TOWN OF FRANKLIN

Re: Beaver Pond Hydro-Raking – Peer Review Comments Amendment

BEAVER POND
HYDRO-RAKING

EROSION CONTROL BARRIER DETAIL
NOT TO SCALE

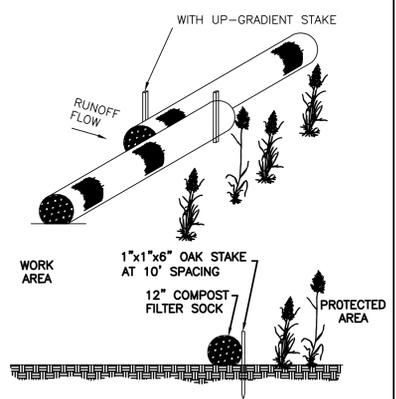
W1. If stockpiles are left onsite for more than 24-hours, the location of the stockpiles should be moved outside of the 25-foot Buffer Zone and BLSF. A secondary stockpile location should be identified on the plans.

DPW will be handling the removal of material from the beach. They will remove these piles daily and/or move to a secondary on-site dewatering area outside of the 25-foot buffer zone and BLSF. These stockpiles are shown on the plans on both sides of the beach.
